Residential Development at Anchorage  
28 North Parade, Falmouth, Cornwall, TR11 2TD

**Resubmission PreApp - Discussion Document, March 2021**

Withdrawn Scheme

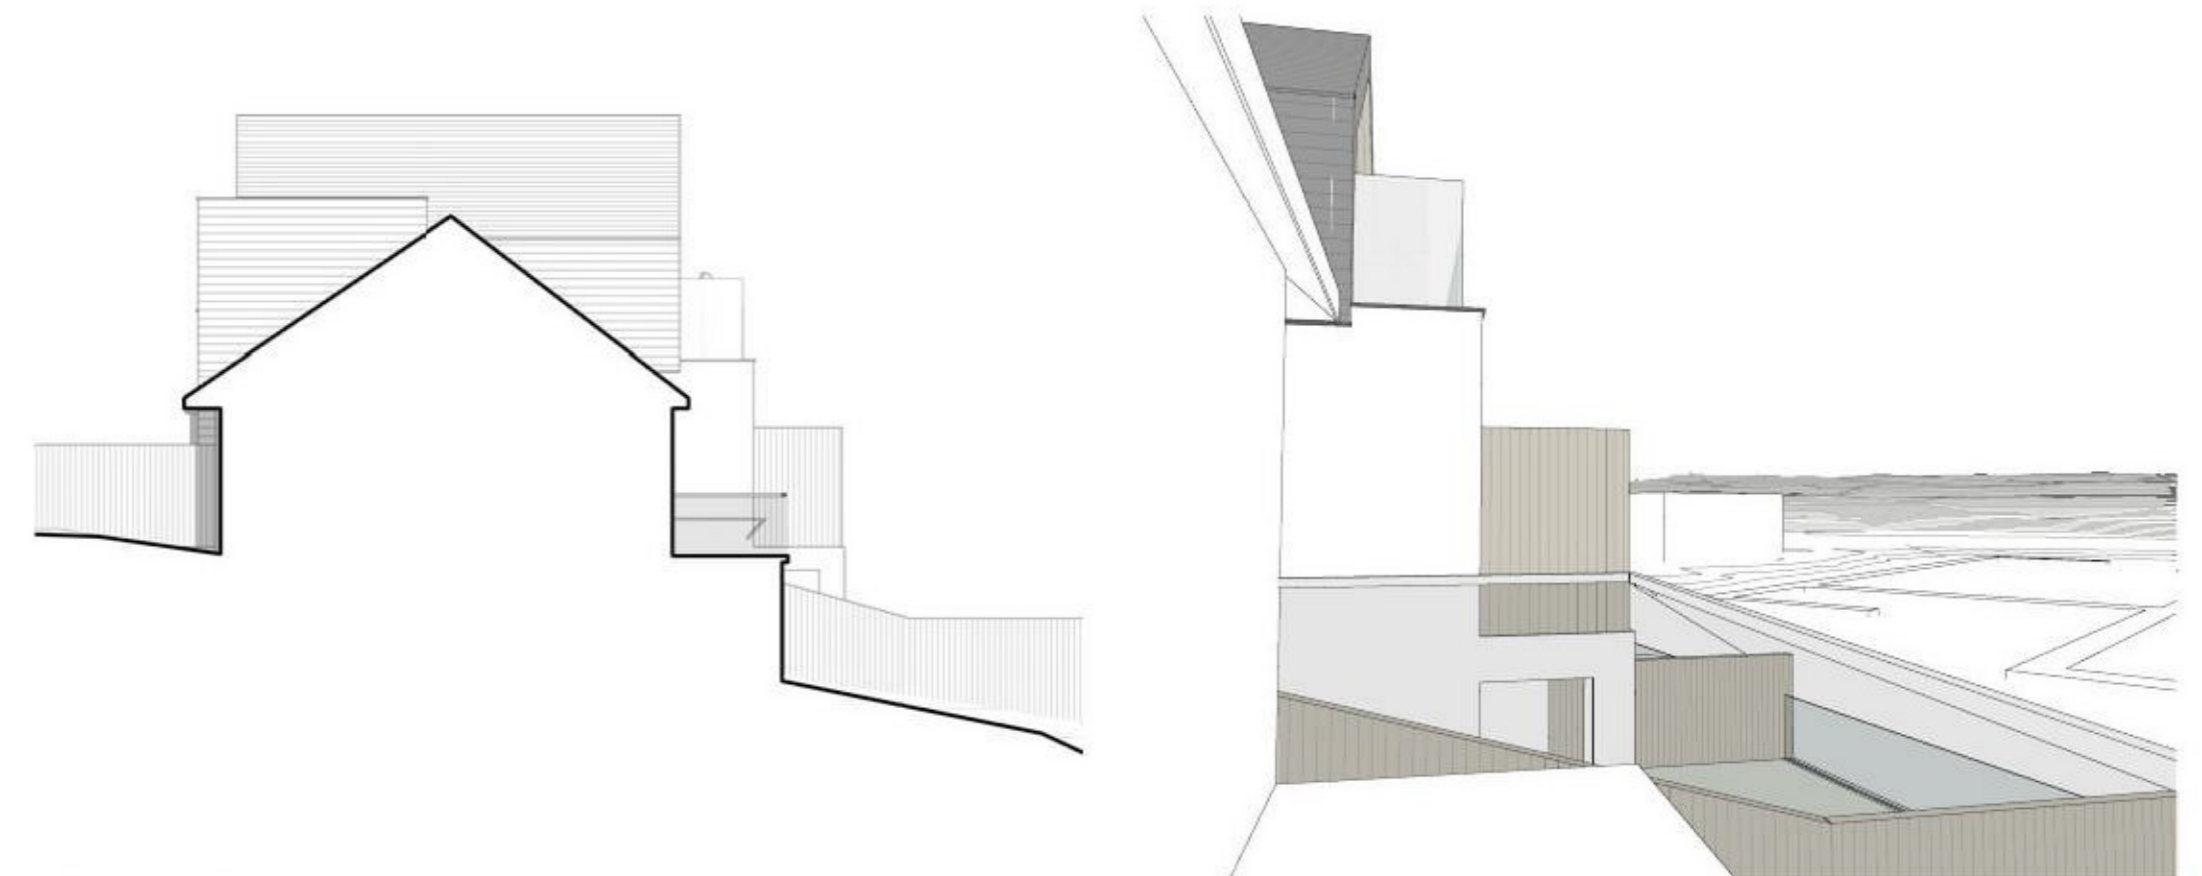
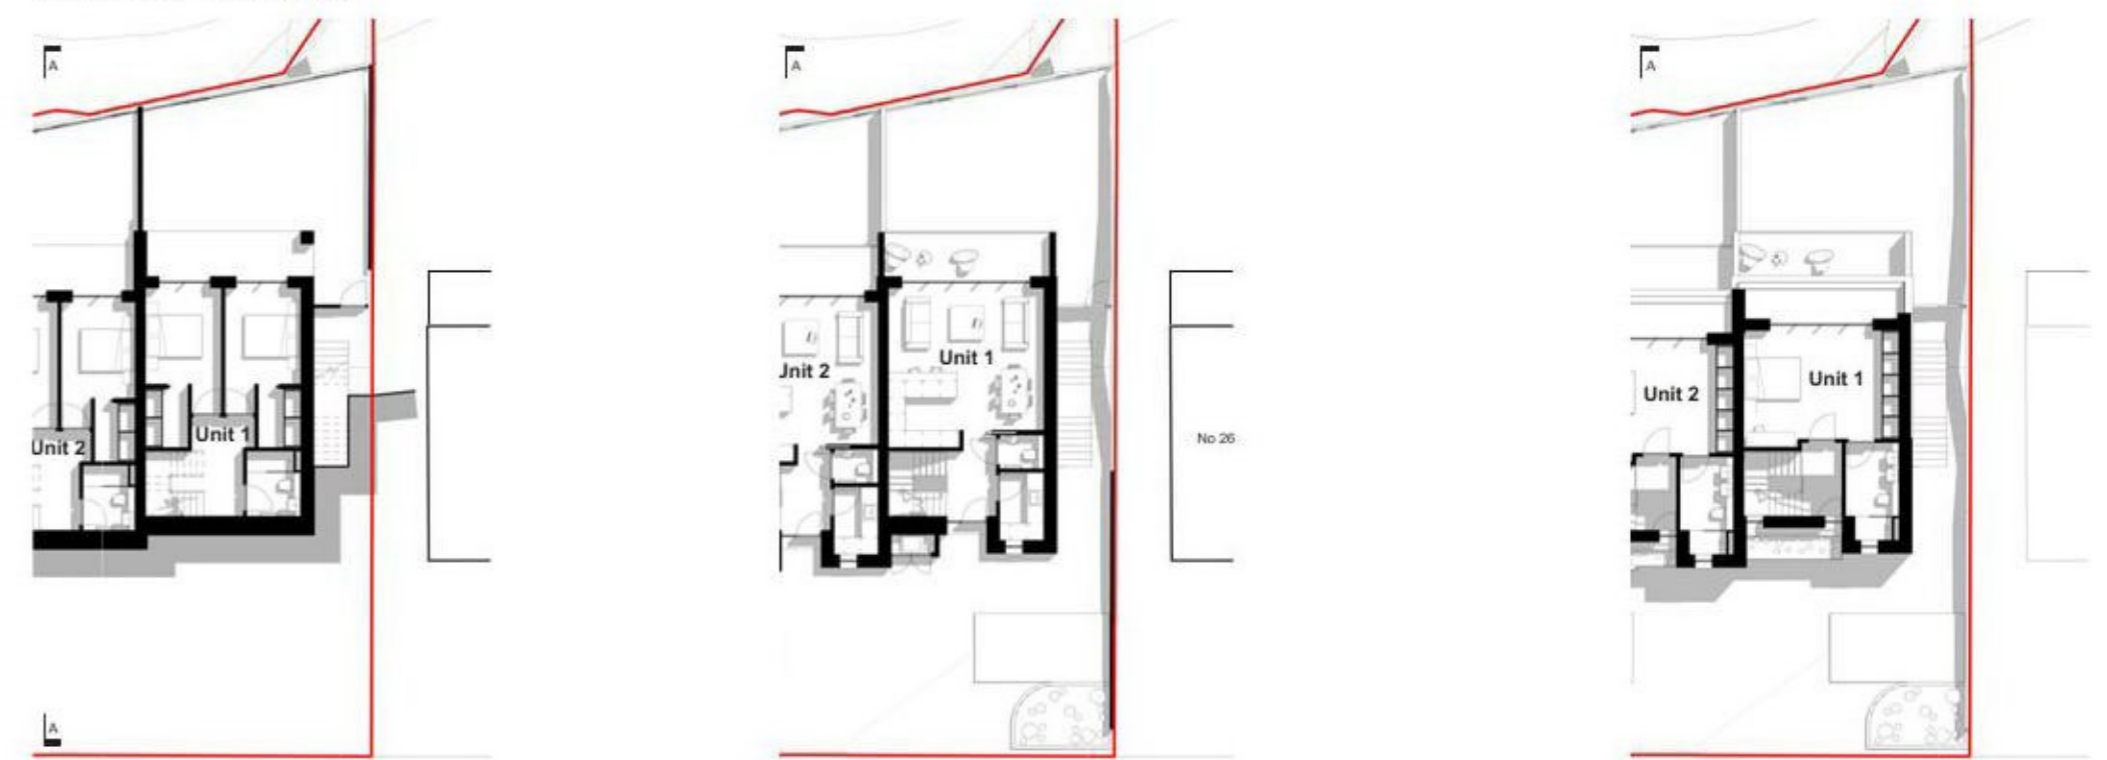
Site visits to neighbours are currently not possible. We utilised the 3D model, which was prepared based on topographical and OS map data to model the view out from the balcony terrace of No 26 to illustrate the impact of the proposed amendments to Unit 1.

Proposed Revised Site Plan

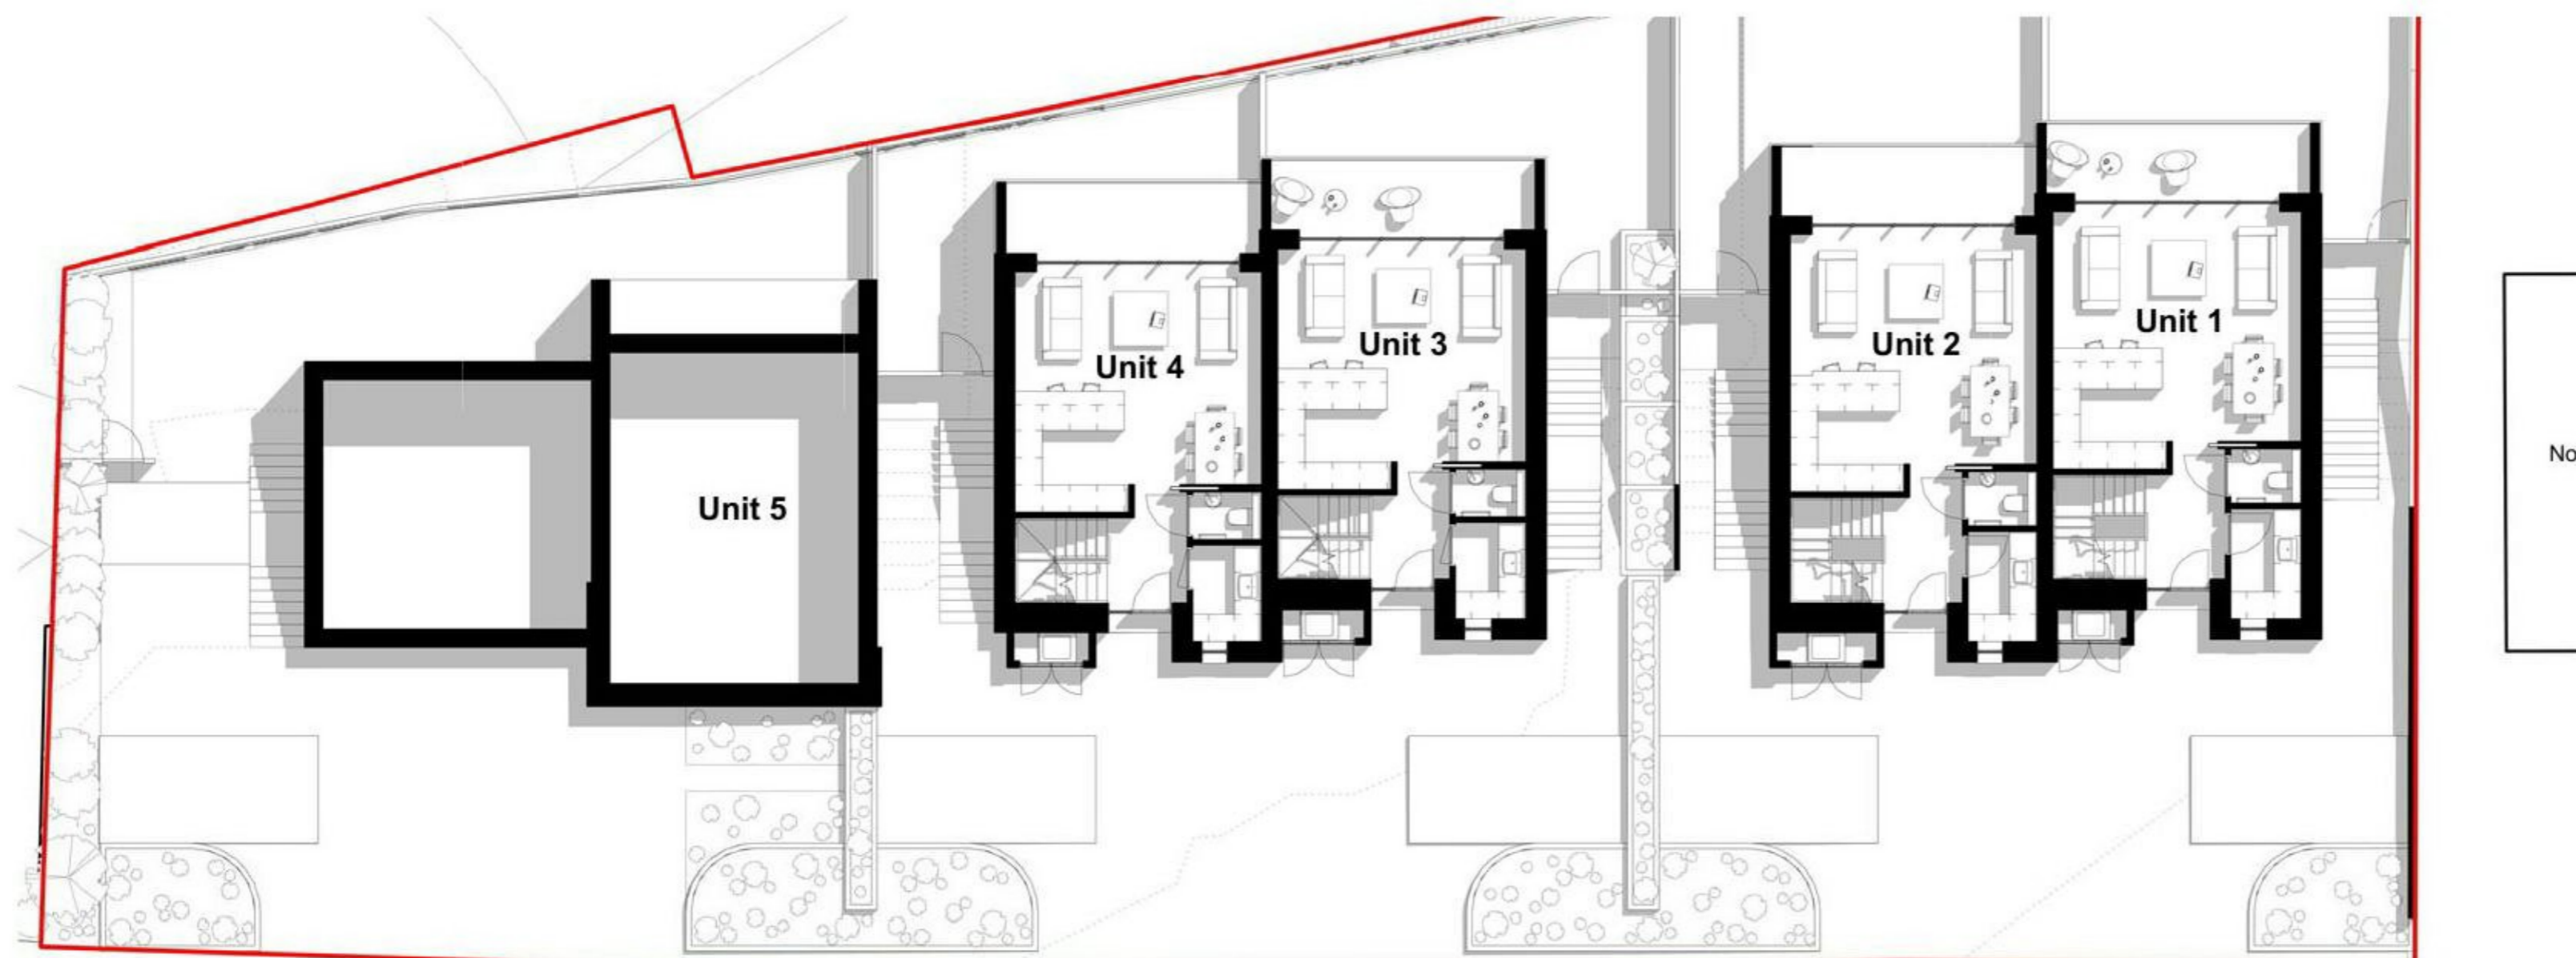
For the proposed revised scheme a parking provision of 1:1 is proposed as suggested in the original PreApp response.

The scale of the development is reduced to 5 units, so a total number of 5 spaces are proposed for this development.

The frontage of each unit has sufficient space to allow for turning a vehicle on the application site. This guarantees manoeuvring in forward gear on and off the highway. Our transport consultant Jon Pearson has undertaken a vehicle swept path analysis to demonstrate this. Parts of this is clipped onto this page, the full drawing is provided alongside this document.

The reduced overall parking provision allows for a deeper soft landscape strip along the site frontage. This reduces the visual car dominance of the scheme's road frontage.
